## PLANNING REVIEW CHECKLIST

**Subject Property:**155 Cottage St NE

**Ref#:** 22-113442-RP (Class 3 Site Plan Review)  
22-113443-ZO (Class 2 Driveway Approach Permit)

**Date** February 03, 2023  
**Project Name** Executive Building Renovation  
**Project No.** Application Number – 23-103081-00-PLN (formerly 22-113442-RP, 22-113443-ZO)  
**Attention** TBD (formerly Liz Olmstead)

**FIGURE 800-10. VEHICLE OPERATION AREA PARALLEL TO FRONT OF ENCLOSURE**

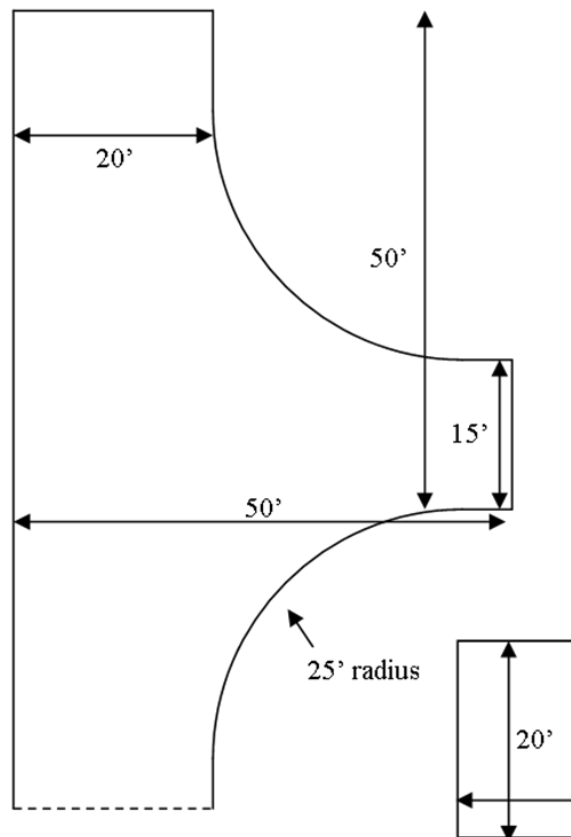
(E) In the event that access to the vehicle operation area is not a direct approach into position for operation of the service vehicle, a turnaround, in conformance with the minimum dimension and turning radius requirements shown in Figure 800-10, shall be required to allow safe and convenient access for collection service.

**Because the receptacles are larger than 2 cubic yards, direct approach is required to the solid waste service area. The code may be addressed, including but not limited to, by the following options:**

<b>2. Provide the turnaround as shown in Figure 800-10 (the solid waste service area would be adjacent to the 15' measurement); or</b>  <b>3. Apply for a Class 2 Adjustment (SRC 250)</b>
<b><u>Class 2 Adjustment</u></b>	An additional application folder will be opened for the driveway spacing Class 2 Adjustment with a fee of \$1,807. I will wait to set up the folder until I hear from you if you are going to apply for the additional Class 2 Adjustment to the Solid Waste Service vehicle operation area. The additional adjustment will be an additional \$250.

**Response: The narrative for section 800.055 has been expanded upon to clarify the limitations for meeting the requirements of a direct approach to the trash enclosure and that a Class 2 Adjustment will be applied for if needed. The narrative includes a response stating how the proposed design meets the required approval criteria under the Class 2 Zoning Adjustment section 250.055(d)(2) to the extent possible.**

**Class 2 Adjustment**  
**Response: We plan to apply for both the Class 2 Adjustment for the driveway spacing as well as the Class 2 Adjustment for the Solid Waste Service vehicle access.**
